Japan comments on *China's proposals for High Voltage Safety*

EVS-GTR IWG#18_June, 2019 @ Tokyo

6.1.6.2.3. Assessment procedure for low electrical energy.

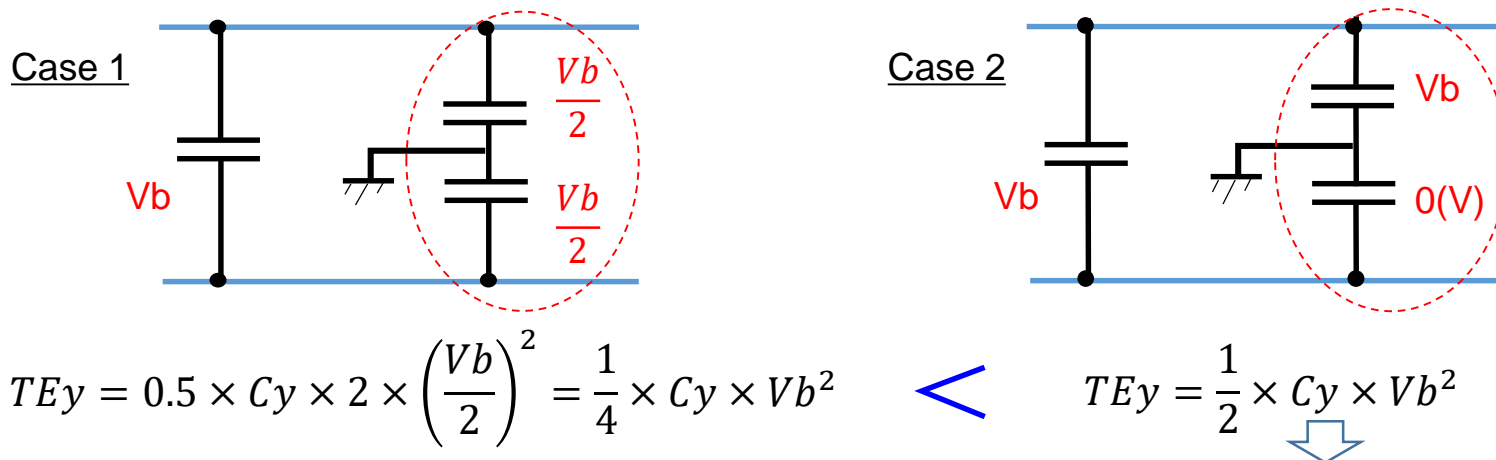
Alternative calculation measure of Y-capacitors' energy should be added in current GTR20 text as an alternative approach.

Add an alternative approach.

$$TEy1 = 0.5 \times Cy1 \times V1^2 \quad TEy2 = 0.5 \times Cy2 \times V2^2$$

Alternatively, the calculation of total energy TEy may be conducted according to the formula below with using Vb .

$$TEy = TEy1 + TEy2 = 0.5 \times Cy \times Vb^2$$

Cy : $Cy1$ or $Cy2$ whichever is higher

Maximum energy can be calculated with using the battery voltage.

New approach for quantifying of “mechanically robust protection”

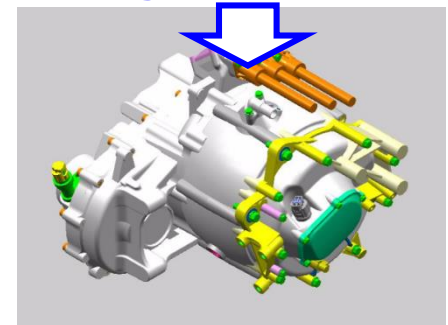
10kPa requirement in China proposal needs to be discussed at EVS-GTR IWG.

- What is the rationale of 10kPa? It seems appropriate because it means putting 10kg weight for the square measuring 10cm by 10cm.
- The evaluation method for 10kPa should be clarified.

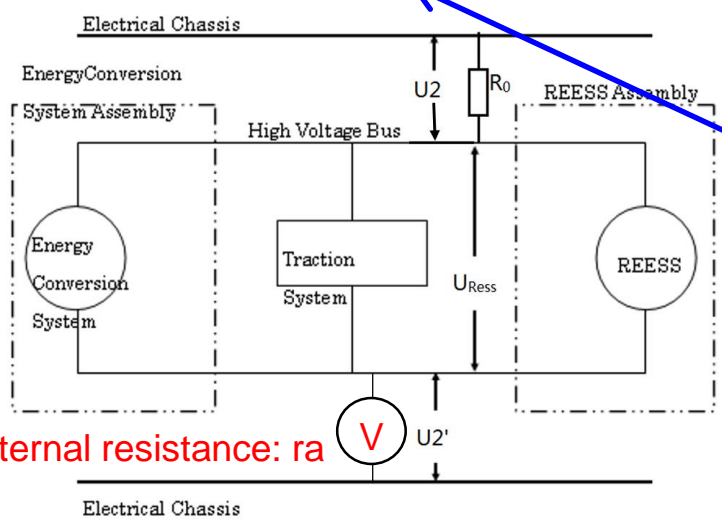
No need to require that the internal resistances are equivalent.

The internal resistance value of the voltmeter connected to U2' side needs to be identified with a high accuracy. The manual or catalog of the voltmeter should be checked beforehand. If there is a deviation specified in a catalog, maximum resistance value should be used for calculation

The isolation resistance calculation formula proposed by China should be revised.

$$R_i = \frac{1}{\frac{1}{R_0 \left(\frac{U_2'}{U_2} - \frac{U_1'}{U_1} \right)} - \frac{1}{ra}}$$

Revise the formula and add text.

$$R_i = \frac{1}{\frac{1}{R_0 \cdot U_{ress} \cdot \left(\frac{1}{U_2} - \frac{1}{U_1} \right)} - \frac{1}{ra}}$$

Derivation of isolation resistance calculation formula

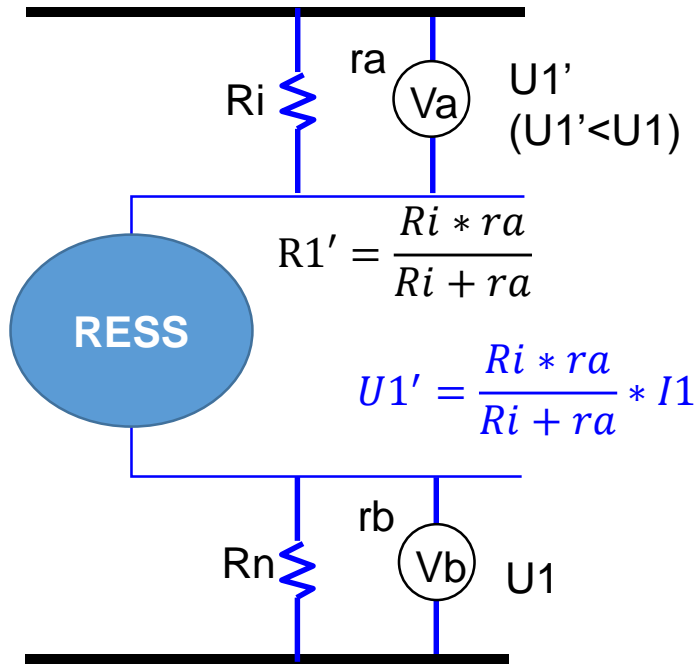
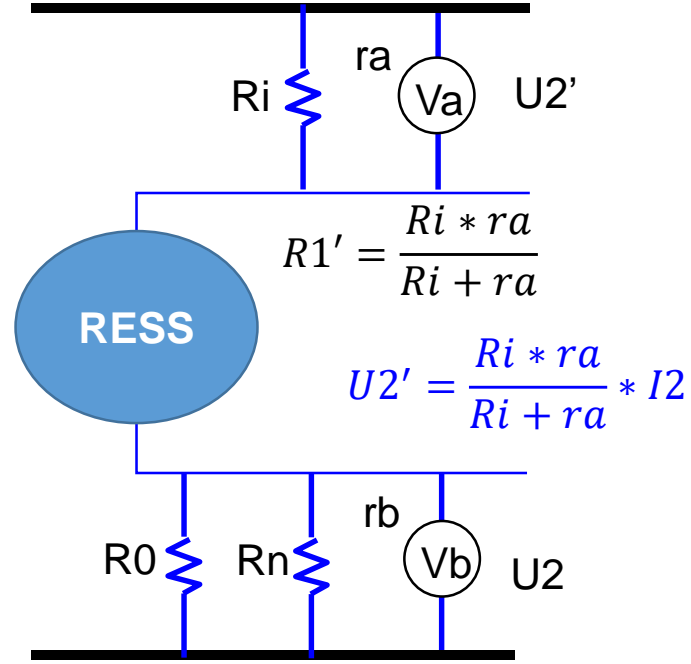
Revised calculation➤ Supposed condition : $r_a \neq r_b$

There is no need to use two voltmeters which have the same internal resistance.

$$\frac{1}{R0 \left(\frac{U2'}{U2} - \frac{U1'}{U1} \right)} - \frac{1}{ra} = \frac{Ri + ra}{Ri * ra} - \frac{1}{ra} = \frac{1}{Ri} \quad \Rightarrow \quad Ri = \frac{1}{\frac{1}{R0 \left(\frac{U2'}{U2} - \frac{U1'}{U1} \right)} - \frac{1}{ra}}$$

Internal resistance of voltmeter

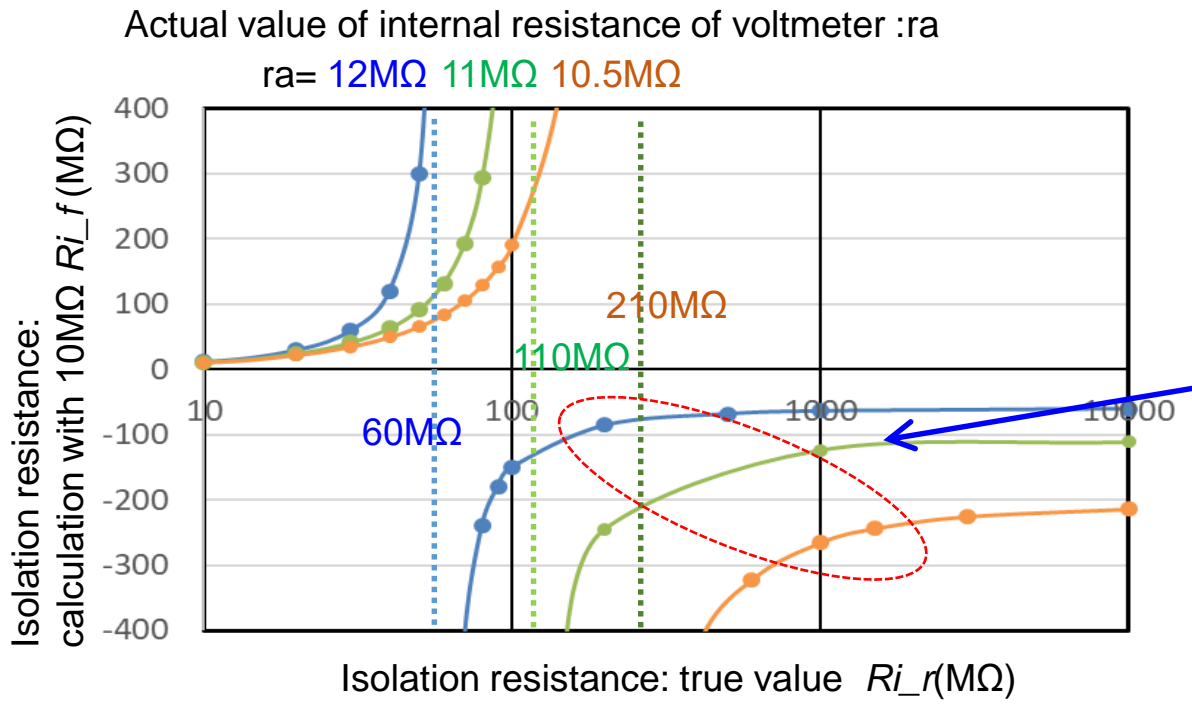
The internal resistance of voltmeter needs to be identified accurately. It should be mentioned in GTR text.

➤ Calculation with substituting 10Mohms as the internal resistance of voltmeter

Minus values are calculated in the case that the isolation resistance is high.

$$Ri_r = \frac{1}{\frac{1}{R0 \left(\frac{U2'}{U2} - \frac{U1'}{U1} \right)} - \frac{1}{ra}}$$

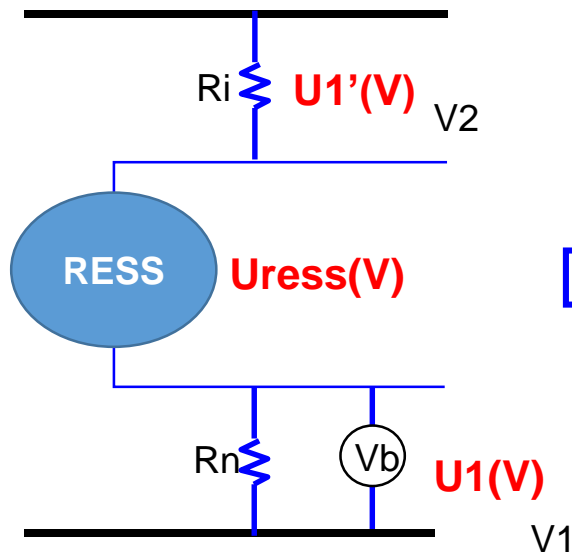
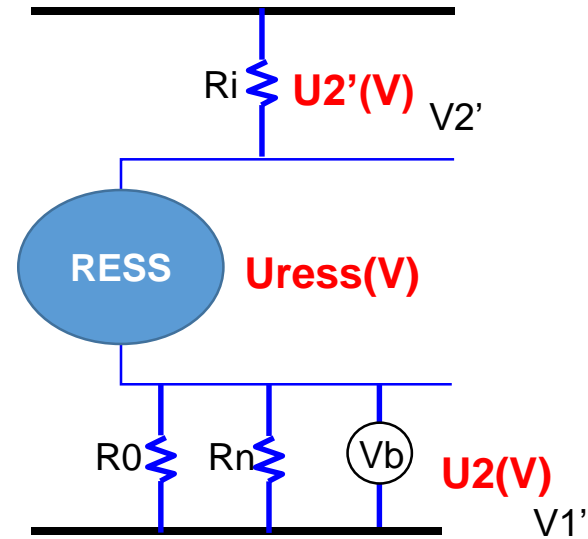
Both formulas are equivalent and should be specified in GTR.

$$R0 \times \left(\frac{U2'}{U2} - \frac{U1'}{U1} \right) = R0 \times \left(\frac{U_{ress} - U2}{U2} - \frac{U_{ress} - U1}{U1} \right) = R0 \times U_{ress} \times \left(\frac{1}{U2} - \frac{1}{U1} \right)$$
